DEVELOPMENT REVIEW COMMITTEE (DRC) COMMENT REPORT

PROJECT NAME: Gallery at Fat Village

CASE NUMBER: UDP-S21013

REQUEST: Site Plan Level II Review: 195 Multi-Family Residential Units, Inclusive of 150 Affordable Housing Units, and 2,500 Square feet Retail Use with 226 Parking Spaces in Downtown Regional Activity Center

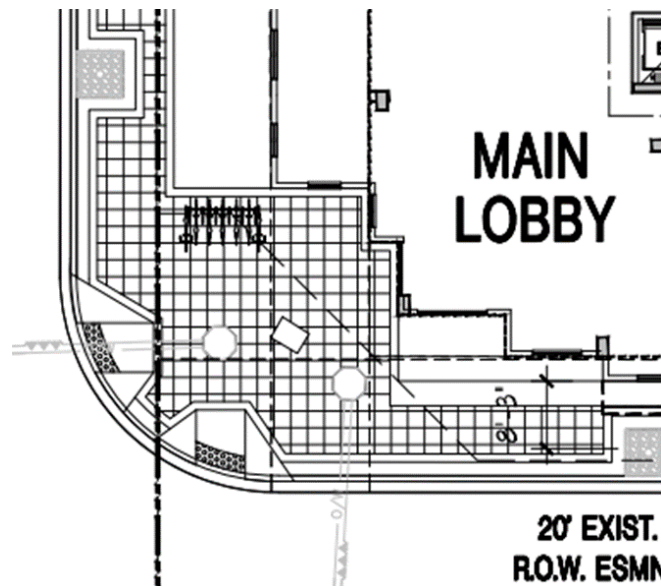
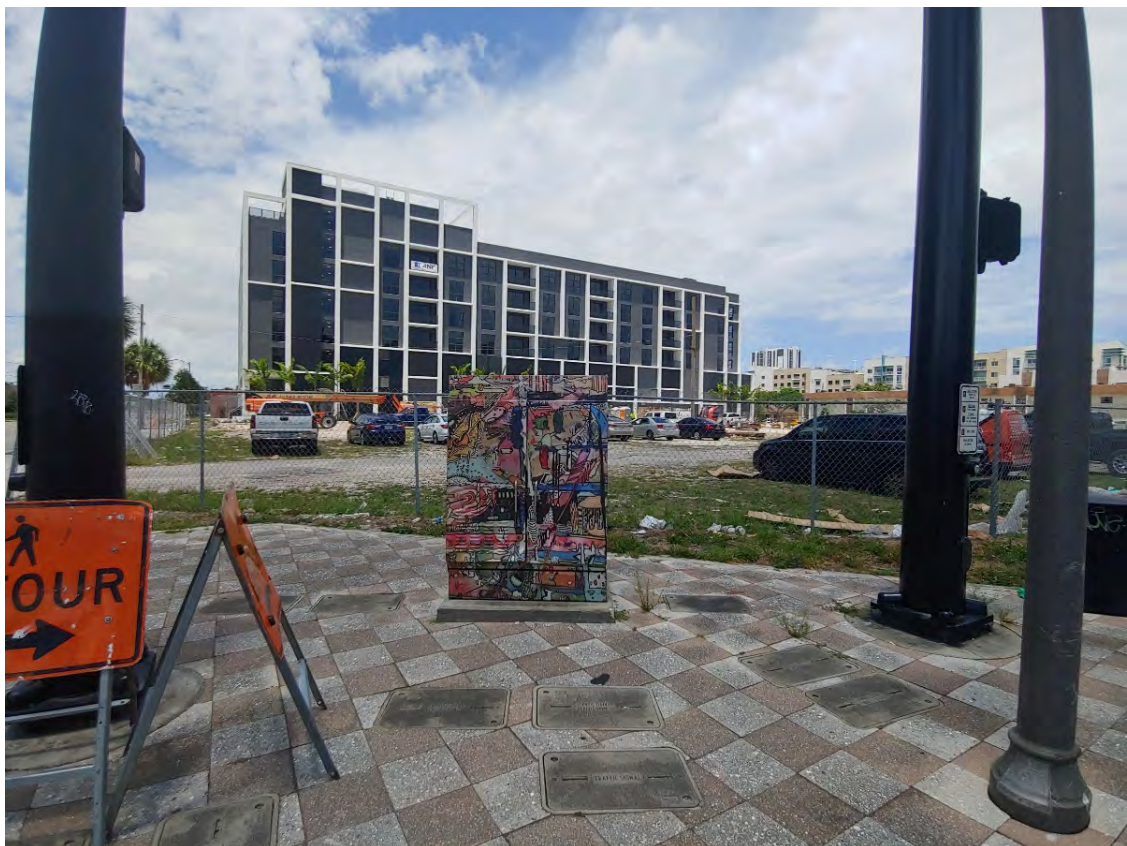
- Per Section 47-13.21.- Table of Dimensional Requirements for the RAC District, the Urban Neighborhood Character Area requires a minimum building tower step back of 12 feet. The plans show a step back of 7 feet, 5 feet less than what is required. Update elevations to the required minimum step back. This is especially important along Sistrunk Boulevard to allow more light and air down to the street level due to the narrow nature of this primary pedestrian corridor.

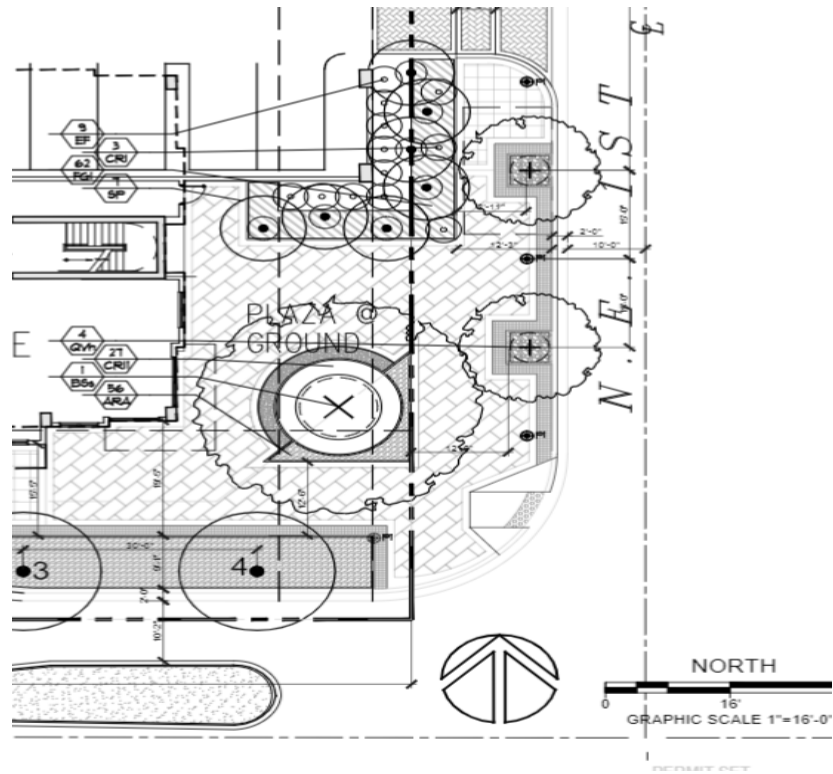
- The signal poles and utility box on the corner of North Andrews Avenue and N.E. 6th Street do not provide a wide enough sidewalk to accommodate a clear pathway for pedestrians and there is a lack of plaza space between the main building lobby and the traffic light poles. Moreover, with the placement of the lobby so close to the poles, the architectural elements of the building's entrance are obstructed. Additional plaza space is recommended to provide adequate space between the traffic light poles, electrical box and main lobby. Consider working with Public Works and Parks and Recreation on changing the location of the light pole to a less obtrusive location.

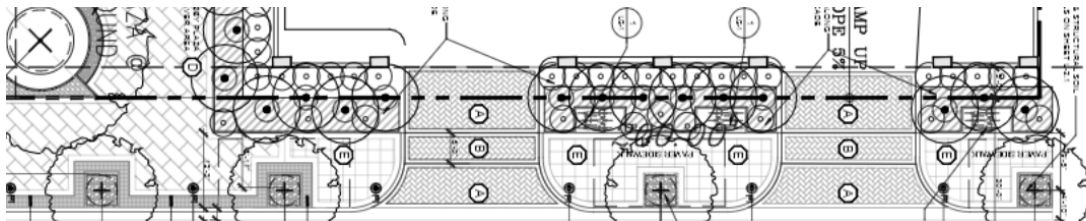
- h. Conflicts between utility boxes on the corner of N.E. 6th Street and N.E. 1st Avenue are affecting the proposed ground plaza and sidewalk clear pathway. The plans state utility boxes will be relocated, but do not specify where. Indicate where the utility boxes are being reallocated, ensuring their new location is less visible from the public right-of-way and outside the sidewalk's clear pathway.

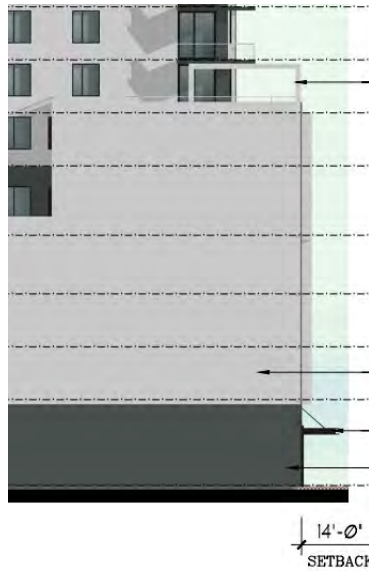
- n. Indicate all adjacent building footprints, indicating their uses and heights...
o. Show centerlines of all adjacent ROWs and dimension widths.
p. Indicate all utilities (both above and below ground) that would affect the proposed planting or landscape plan.
q. Will the curb cut along N.E. 6th Street be removed?
